Proposed Revisions to a Standard Plans Index

Index Number: 120-001

Index Title: Embankment Utilization

Summary of the changes:

INDEX	SHEET
120-001	1 of 3

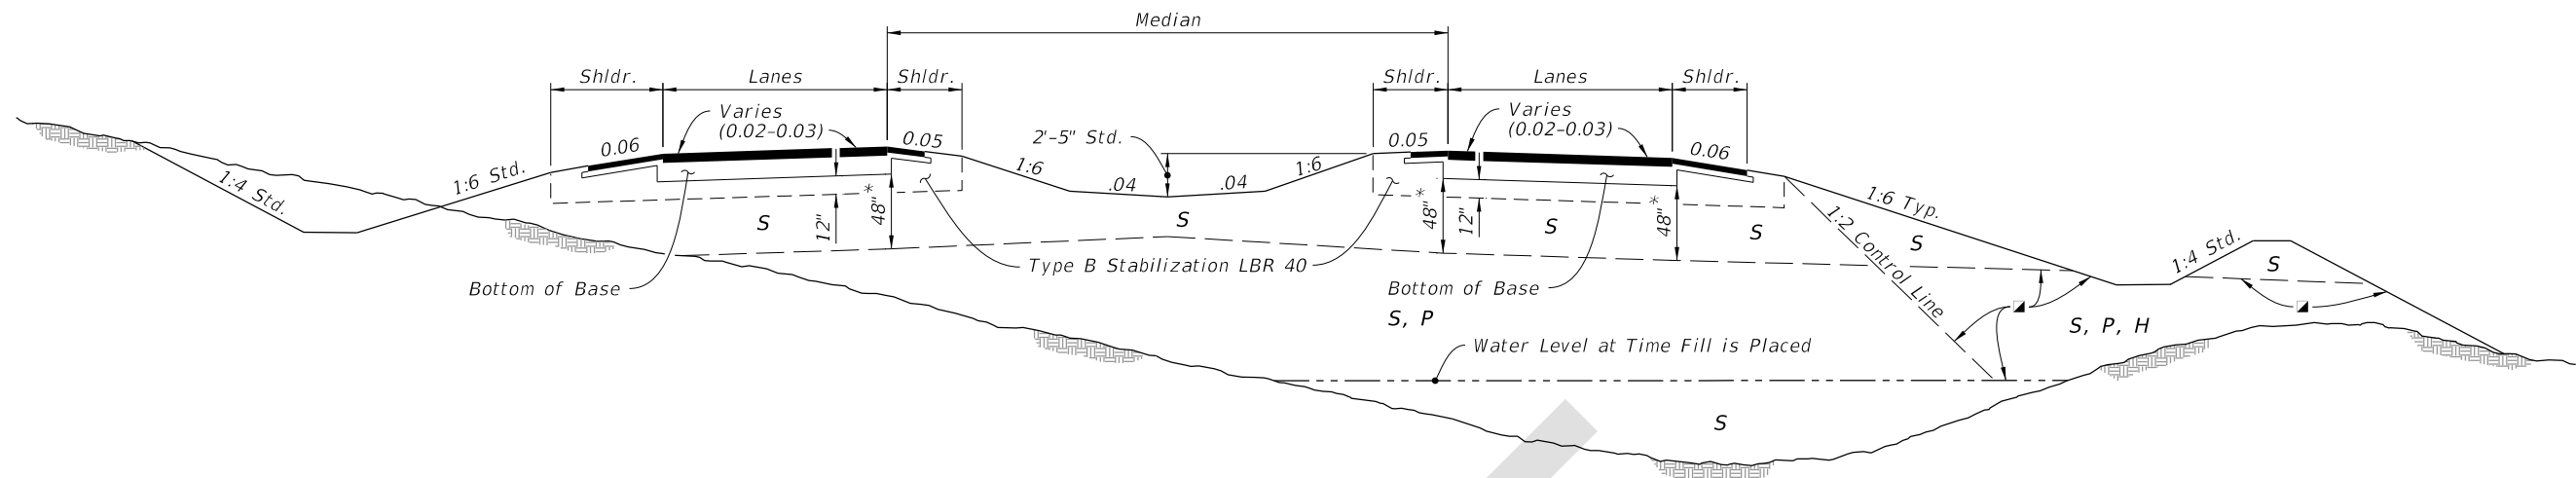
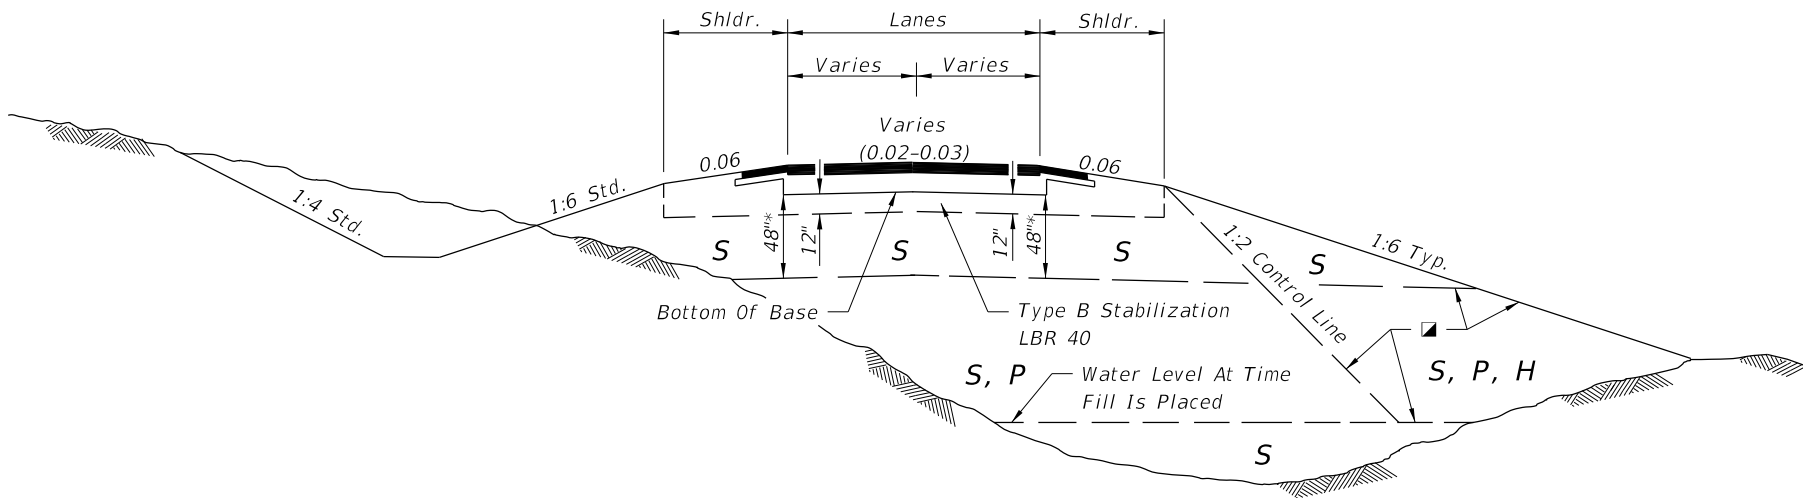
Update Note 4 to reference proper testing

Specification 120 and Index 120-001 have contradicting testing information. Change Index to "Perform tests in accordance with FM 1-T 267."

FM 1-T 267

- Select (S) soils having an average organic content of more than two and one-half (2.5) percent, or having an individual test value which exceeds four (4) percent, are not permitted in the subgrade portion of the roadbed. Select (S), Plastic (P), or High Plastic (H) soils having an average organic content of more than five (5) percent, or an organic content individual test result which exceeds seven (7) percent, are not permitted in the portion of embankment inside the control line, unless written authorization is provided by the District Geotechnical Engineer; these soils may be used for embankment construction outside the control line, unless restricted by the Plans or otherwise specified in the Plans, provided they can be compacted sufficiently to sustain a drivable surface for operational vehicles as approved by the Engineer. Determine average organic content from the test results from a minimum of three randomly selected samples from each stratum or stockpile of a particular material. Perform tests in accordance with FM 1-T 267.
